NIDEC MOTOR CORPORATION 11-Aug-23

REVISION RECORD FOR: ECO E45072

TITLE	CODE	ITEM NO.	REV	SHEET NUMBER	DWG SIZE
CUSTOMER DETAIL DRAWING	V02	804390	C	1 OF 6	B

EXTERNAL CONNECTIONS

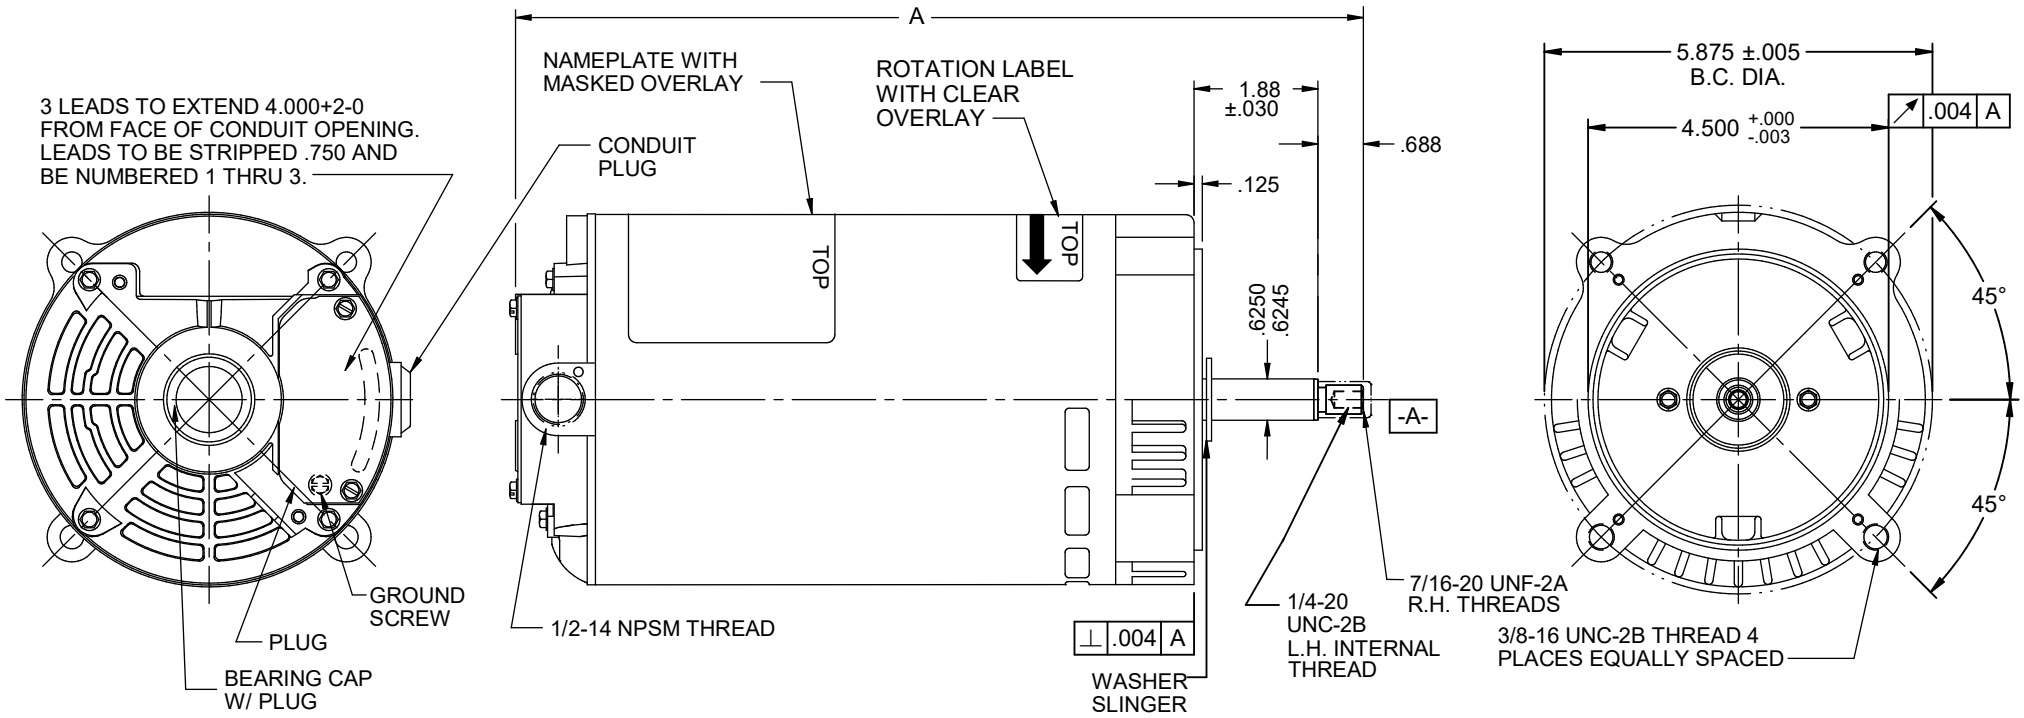
CHANGED ROTATION FROM CW LEAD END TO CCW DRIVE END

WITH ABC PHASE SEQUENCE
PHASE A - LINE 1
PHASE B - LINE 2
PHASE C - LINE 3
ROTATION IS CCW DRIVE END
